Access Compliance Report Public Rights-of-Way (Curb Ramps)

Main Street: E_CASSELLE_AVE Cross Street: PROSPECT_ST Location: SE

ADA ID: RPRK220222195740 Ramp Type: Type 4 - Parallel Initial Pass/Fail: Pass Overall Compliance: No Severity Score: 0

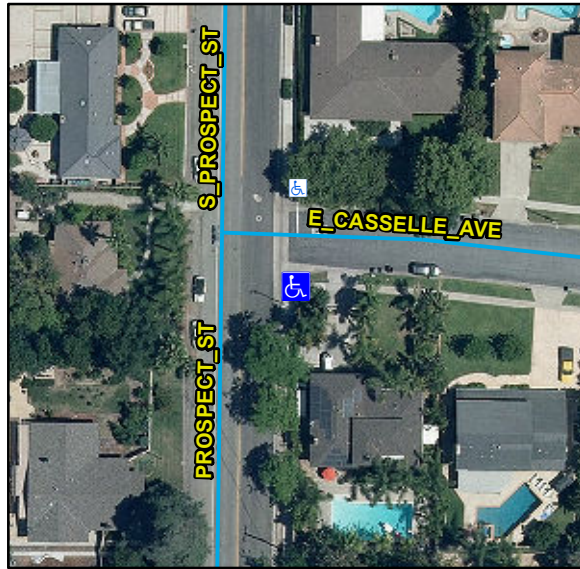
Crossing 1 Slope (%)	3.7		Crossing 2 Slope (%)	1.2
	Crossing 1 Cross Slope (%)	0.5		Crossing 2 Cross Slope (%)	1.5
Yes	Gutter Ponding	No	Yes	Curb Slope	0.3
Yes	Gutter Lip Height (in)	0		Road Run Slope (%)	3.3
Yes	Gutter Run Slope (%)	2.2		Road Cross Slope (%)	5.3
No	Gutter Cross Slope (%)	3	Yes	Perpendicular Joint Present	Yes
Yes	Overall Surface Condition	Acceptable			
	Cross Gutter Present?	Yes		Spandrel Present?	Yes
	Replace Cross Gutter?	No		Replace Spandrel?	No

Remove & Replace Gutter.

R304.5.3, STD 1115
